**ADDENDUM  
NO. 3**

**September 30, 2025**

**VALE FACILITY ADDITION/RENOVATIONS AND  
MAINTENANCE/IT FACILITY PROJECTS**

**Addendum Three (AD.03)** to the drawings and specifications prepared by Gibraltar Design for **Valparaiso Vale Facility Addition/Renovations and Maintenance/It Facility and Related Work** for Valparaiso Community Schools, Valparaiso, Indiana.

**A-301**

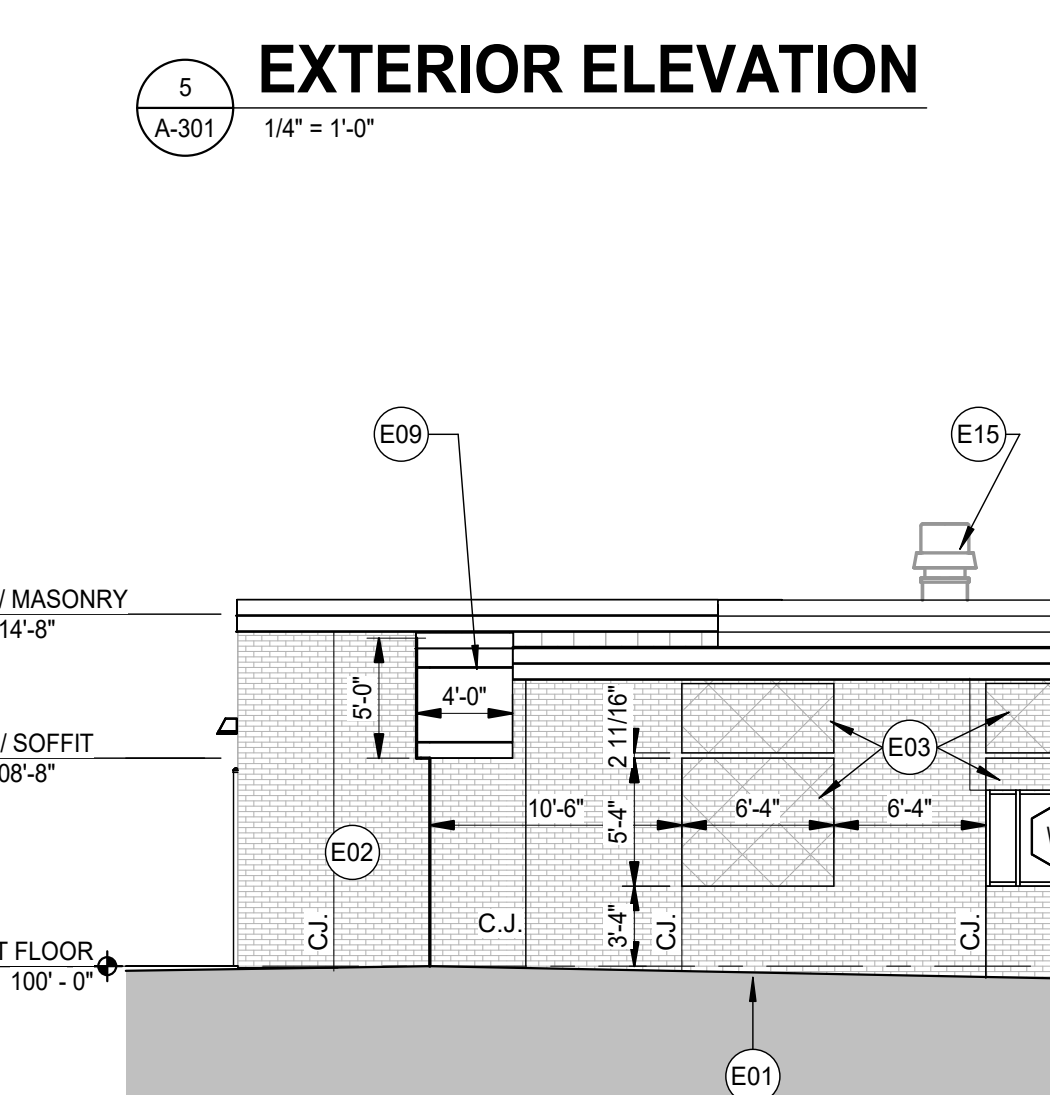
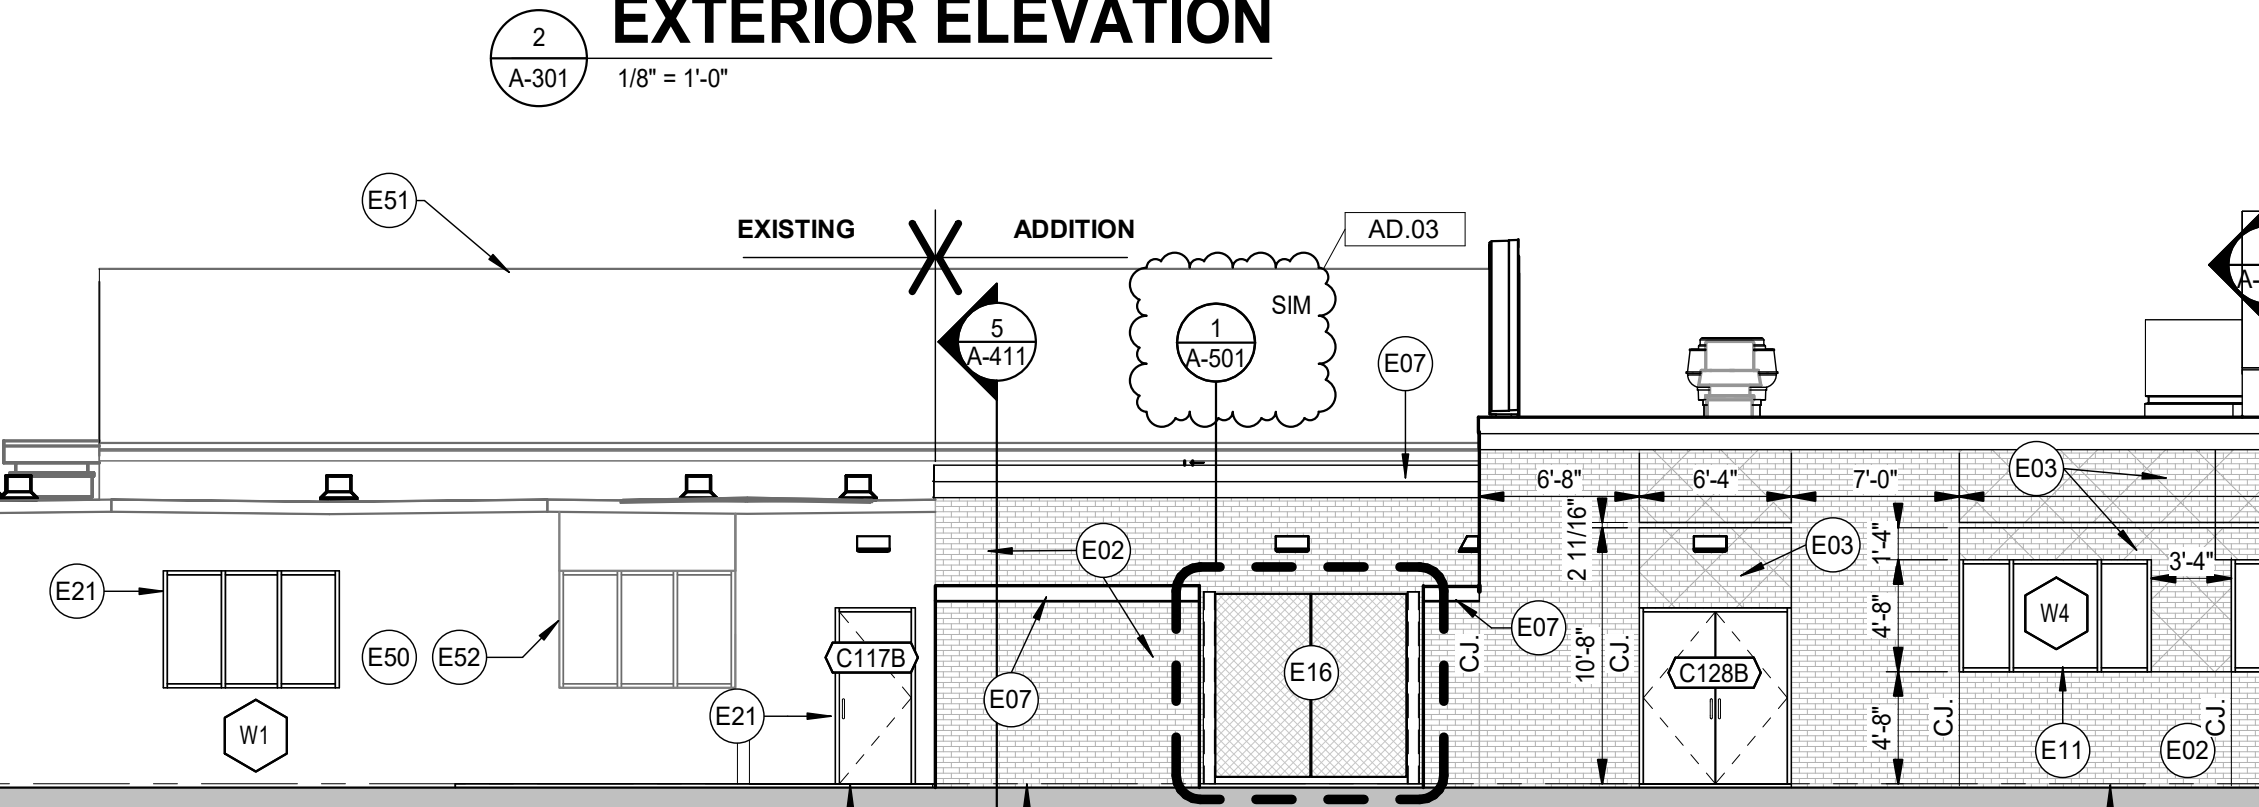
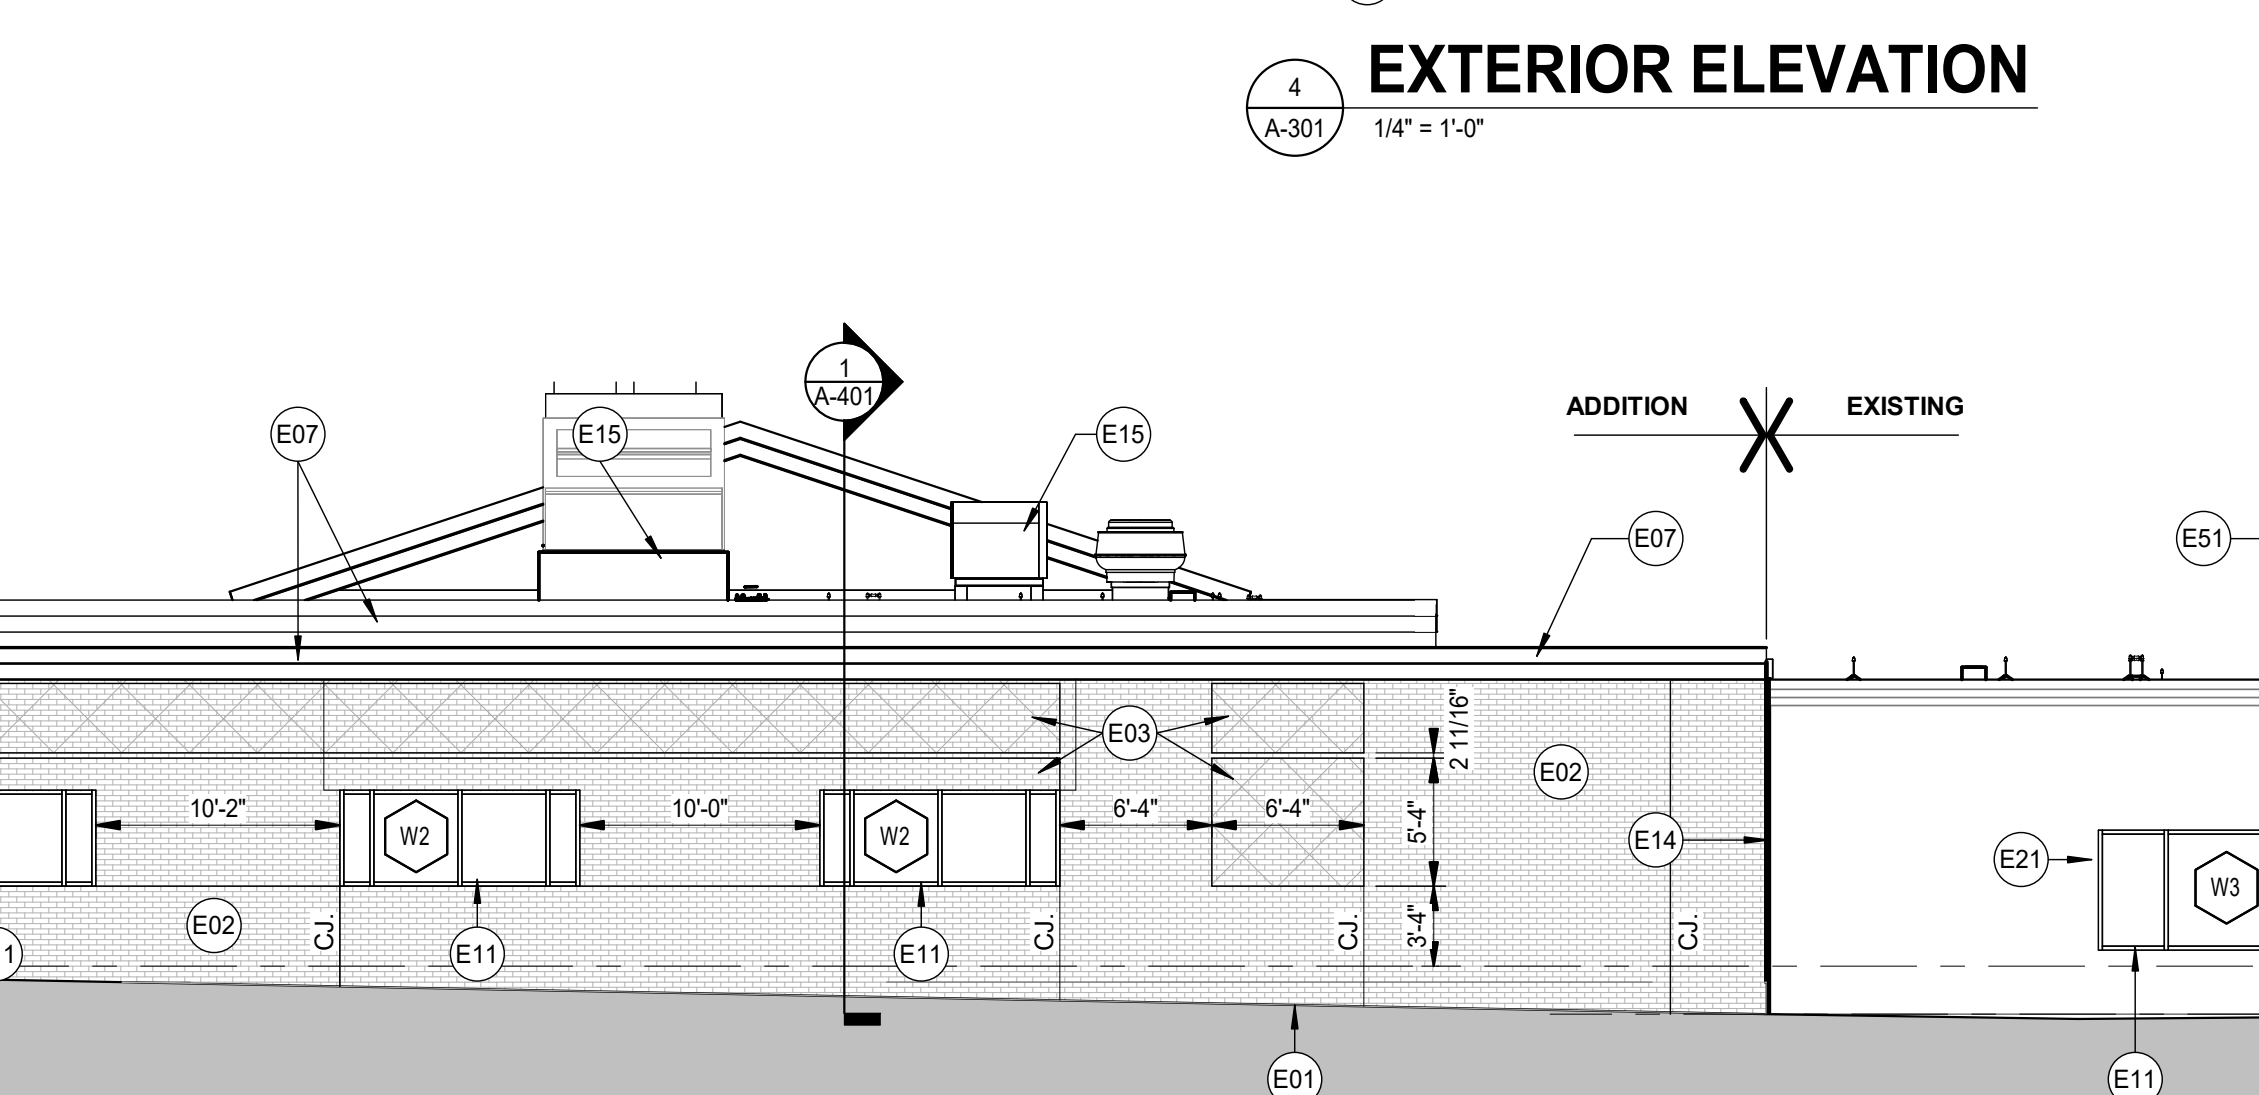
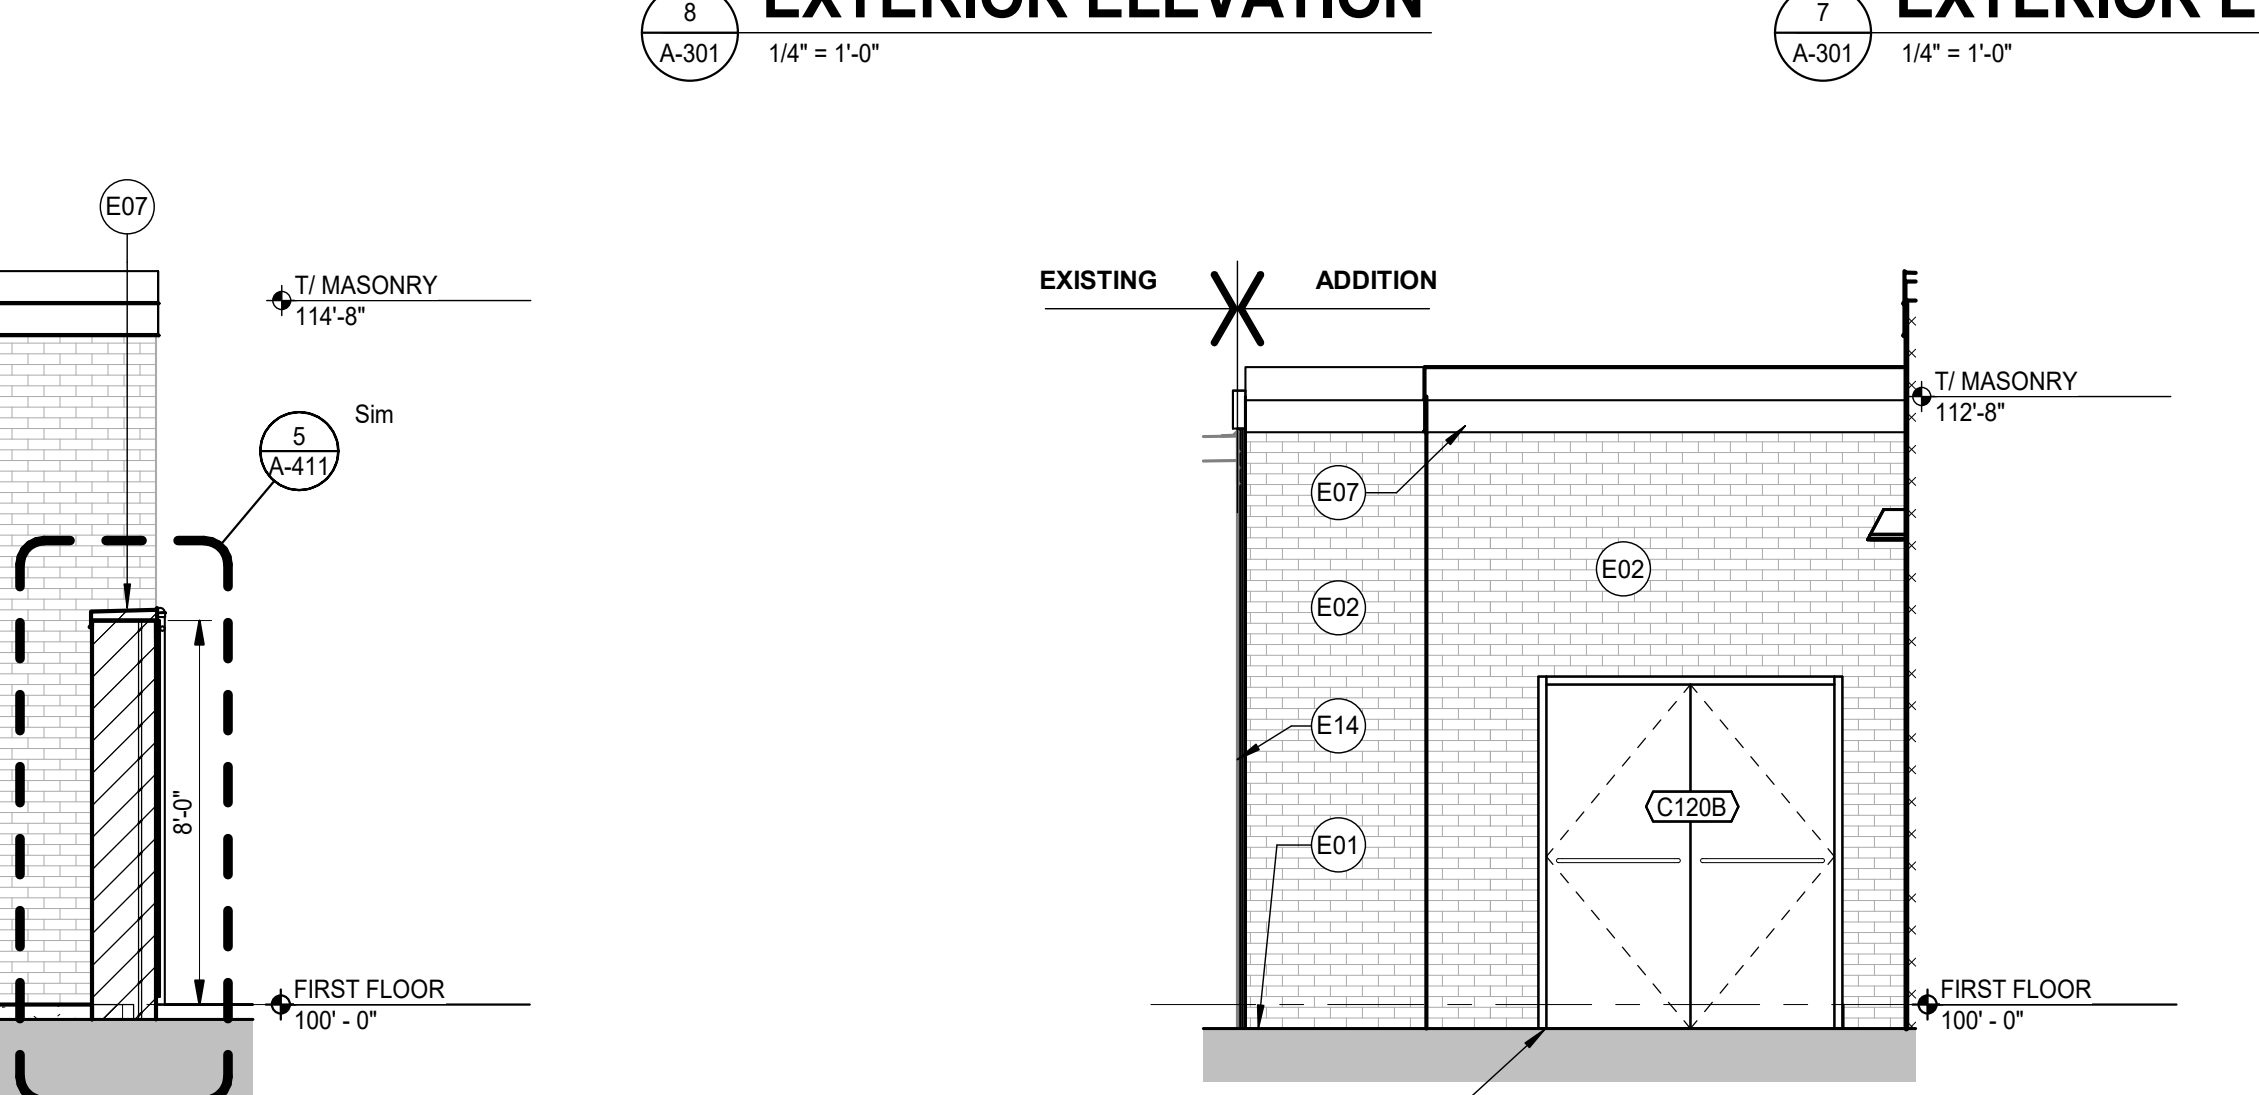
- A. Refer to revised, full-size drawing, included in this Addendum, for revisions.
  1. Added references to detail 1/A-501 at Exterior Elevation 1 and 6.
  2. Modified note E16 to refer to detail 1/A-501.
  3. Added control joints on elevations.
